APPROVED MINUTES

February 17, 2022 Standards Committee Meeting

RE: Minutes from the February 17, 2022 Standards Committee Meeting

E 715-BKFL-01 PIPE BACKFILL METHOD 1 NEW ROADWAY, TRENCH (shown markups)

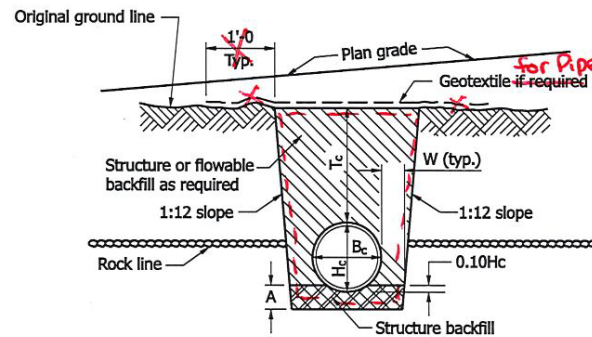
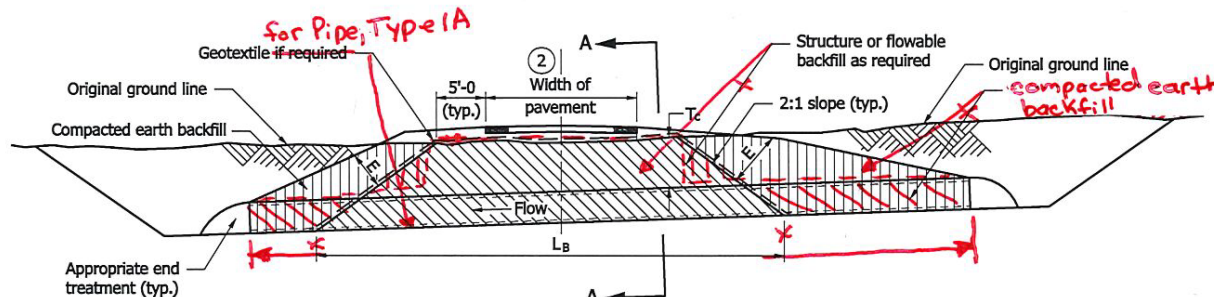
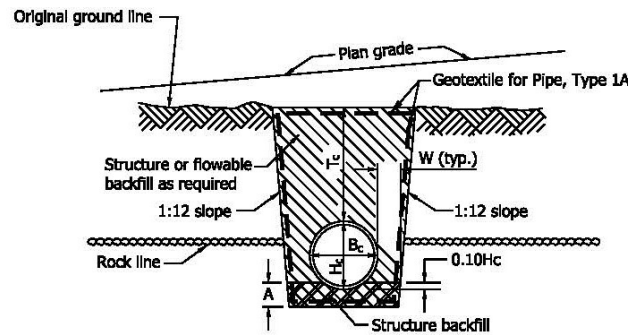
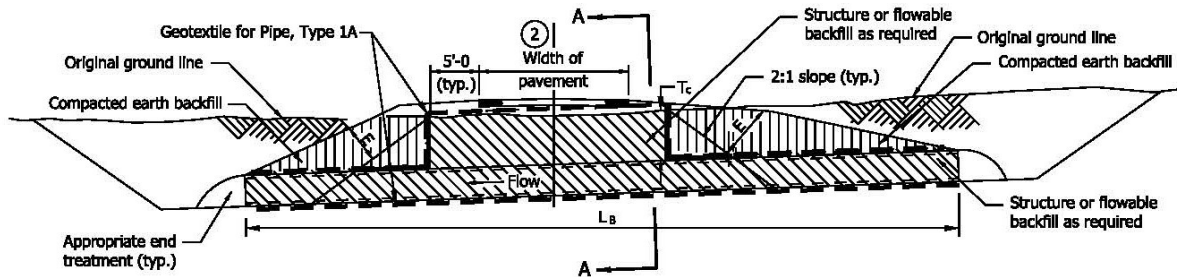
PROBLEM(S) ENCOUNTERED: Currently the Standard Drawing Series 715-BKFL only shows the geotextile capping structure backfill of pipes to prevent infiltration.

PROPOSED SOLUTION: Infiltration can occur anywhere around the structure backfill, therefore for, in most locations, structure backfill should be lined and capped. Have all type 1, 2, 3, and 4 structure backfill for pipes lined and capped with geotextile. Where flowable fill is used in lieu of structure backfill geotextile will not be required. In addition, all the geotextile material to be used to line and cap a pipe will be paid for as Geotextile for Pipes.

REVISION TO STANDARD SPECIFICATIONS, SPECIAL PROVISIONS, AND STANDARD DRAWINGS
 E 715-BKFL-01 PIPE BACKFILL METHOD 1 NEW ROADWAY, TRENCH (proposed DRAFT)

E 707-BPBF-01 FABRICATION TOLERANCES PRESTRESSED BOX BEAM (shown markups)

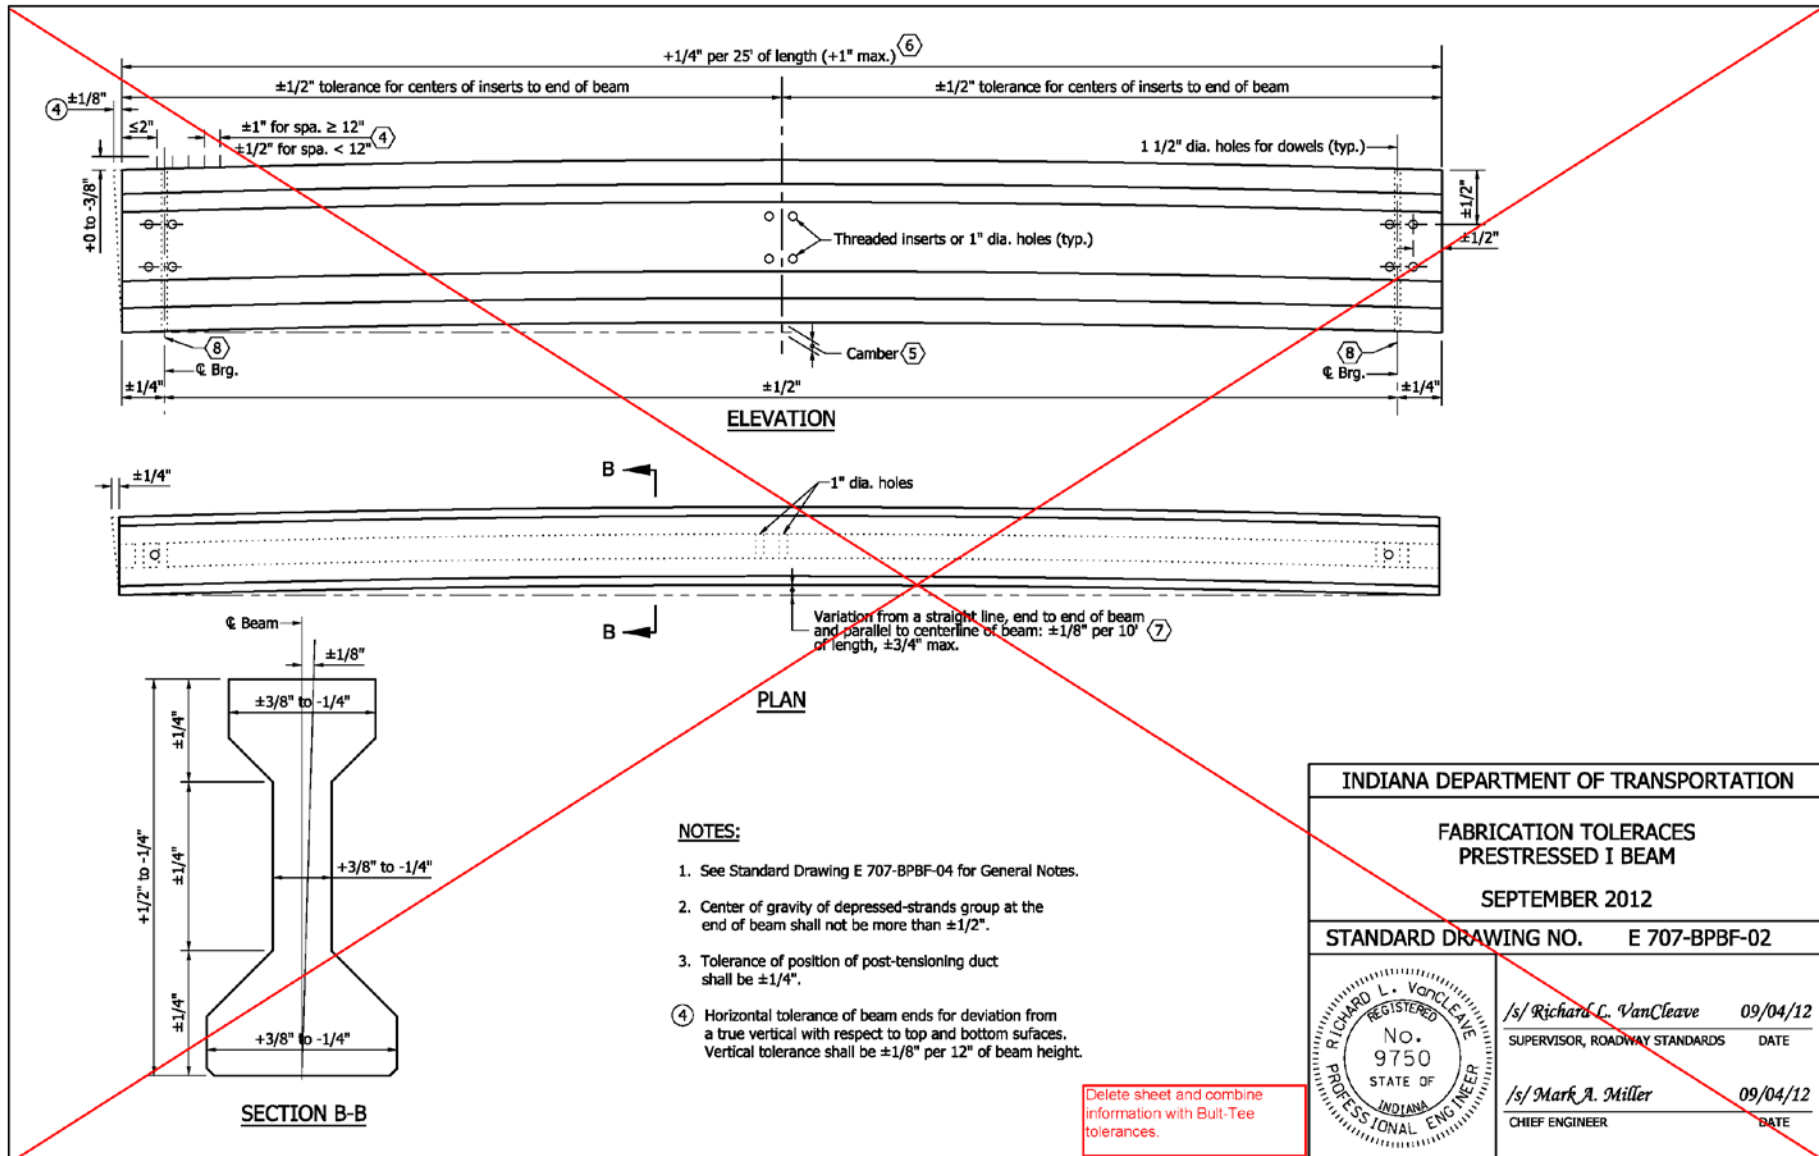
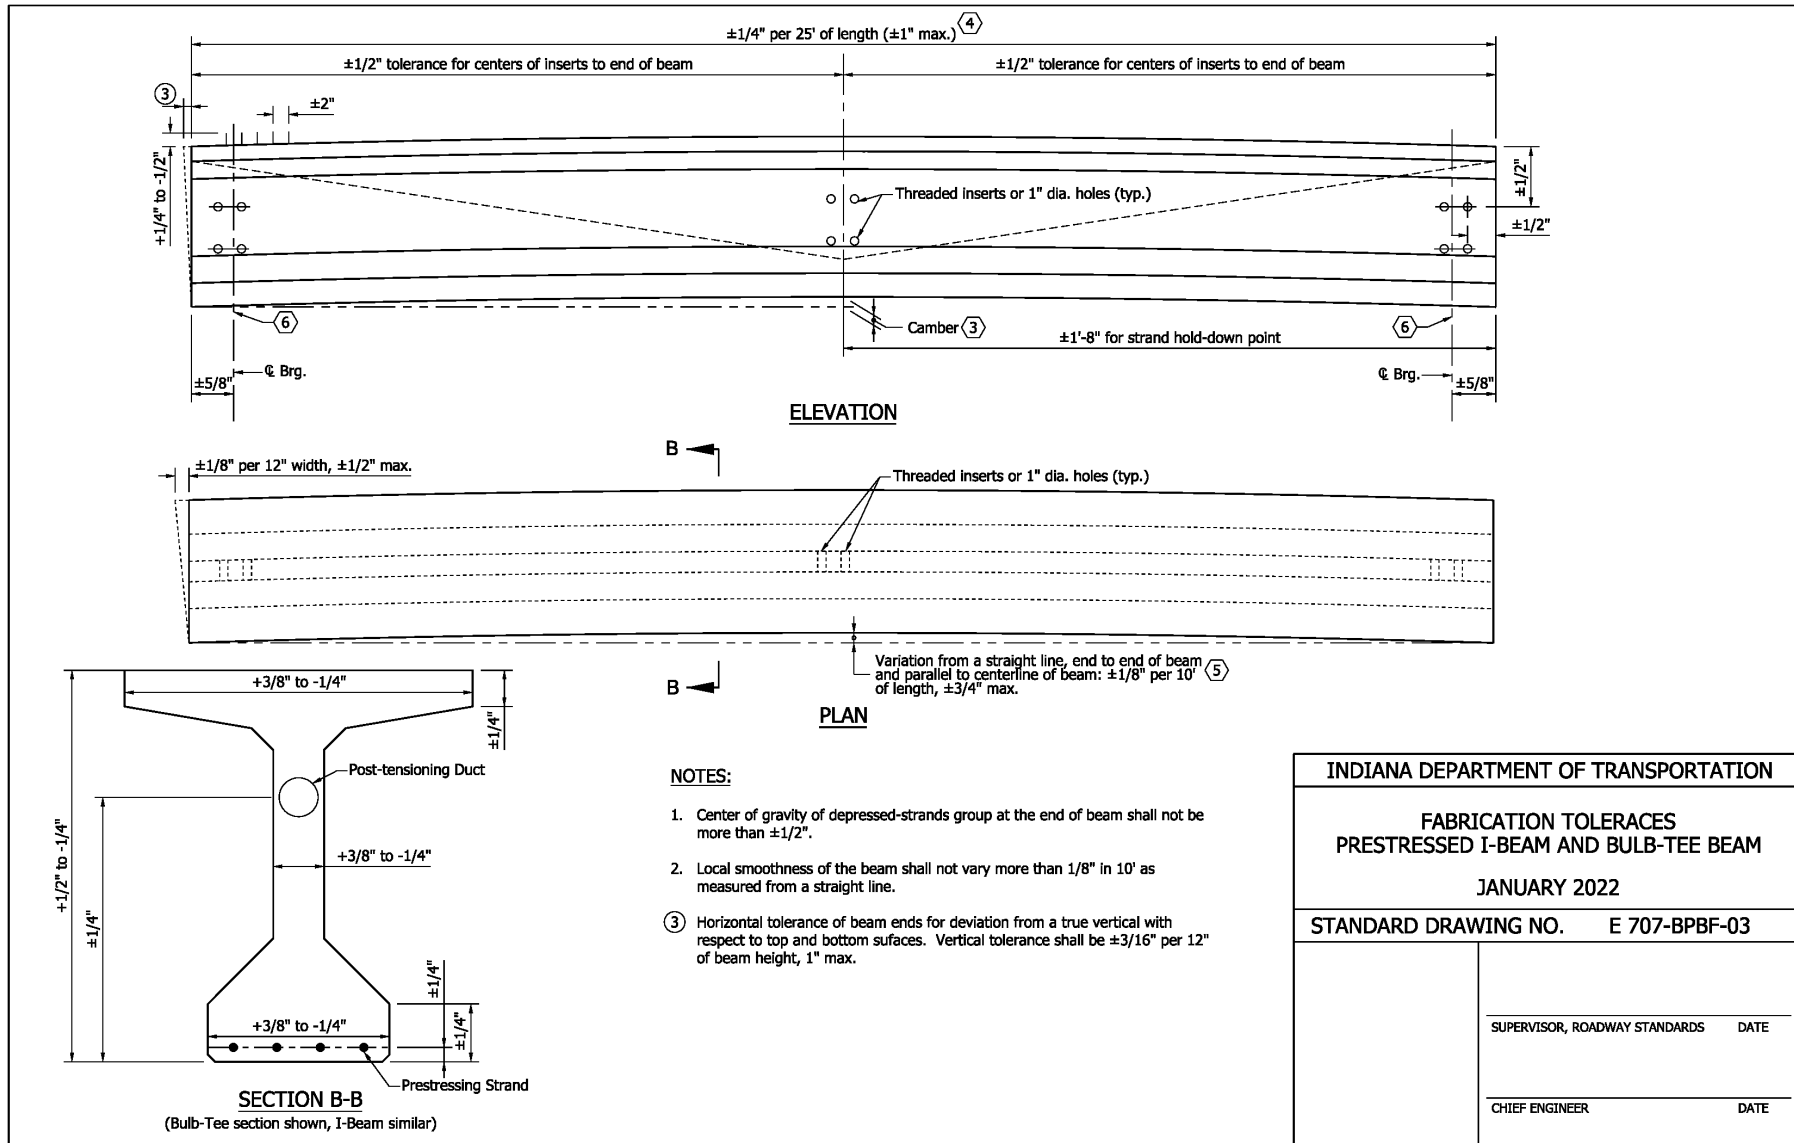
PROBLEM(S) ENCOUNTERED: The E 707-BPBF series Standard Drawings were last published in 2012 and are not in the current format for Standard Drawings. The current sheet 03 shows tolerances for the placement of lifting loops, which are determined by the manufacturer and are not detailed on the design plans. This has caused confusion and delays in the shop drawing review process.

PROPOSED SOLUTION: Several minor changes to the fabrication tolerances are being proposed in order to provide more consistency with the Precast/Prestressed Concrete Institute Tolerance Manual for Precast and Prestressed Concrete Construction, First Edition, Fourth Printing. Since the tolerances for AASHTO I-Beam and Bulb-Tee Beams are the same, current sheets 02 and 03 are being combined into one sheet. The lifting loops that are currently shown on sheet 03 are being removed in order to avoid confusion related to the responsibility of detailing those items.

- 6 ~~8~~ At concrete bearing area, deviation from plane surface when tested in all directions of the plane surface with a steel straightedge shall not be more than $\pm 1/16"$ ~~$\pm 1/8"$~~
